**Pebble Mine Geohazard and Tailings Dam Embankments Analyses of
Dr. T. O'Rourke and Dr. Izzat M. Idriss**

TO: Bristol Bay Reserve Association
FROM: Tom O'Rourke
RE: Geohazards Affecting the Pebble Mine Complex

Subject: *Review of Selected Portions of the Draft Environmental Impact Statement (DEIS) for the Pebble Mine Complex Related to the Tailings Dam Embankments*

Figure reproduced from the DEIS.

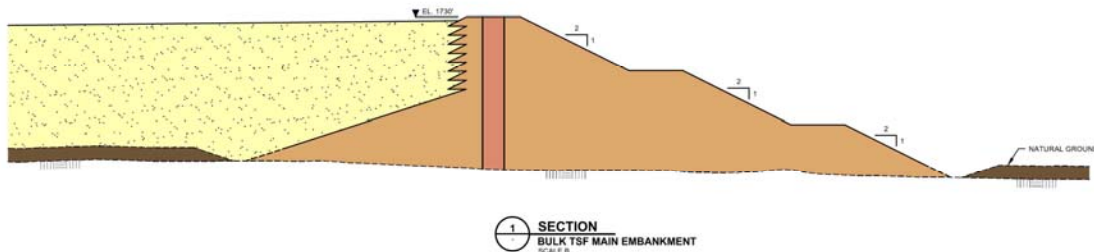
The embankments cross sections I found in the portions of the DEIS I reviewed are more of a "cartoon" rather than a useful engineering cross section that depicts the various zones of the embankment (core, shell, filter and drainage layers) and underlying foundation layers (soil layers, rock). The maximum section of the bulk tailings storage facility (TSF) is included in the DEIS and is shown below to illustrate the inadequacy/incompleteness of the information provided for review.

Far more details are required, including extent (depth and width) and material properties, for each embankment zone and for each foundation soil layer. In addition, the key properties of the underlying rock units need to be provided and analyzed in the DEIS.

The "Christmas-tree" upstream zone of the section of the bulk TSF embankment, shown in the figure above, requires unique details to be successful, such as: (i) adequate beach; (ii) upstream filters; (iii) minimum width and compaction of the upstream shell and of the filters; (iv) minimum width of core; and (v) appropriate geochemical/geotechnical characteristics of the core materials; etc. None of these details are included in the DEIS.
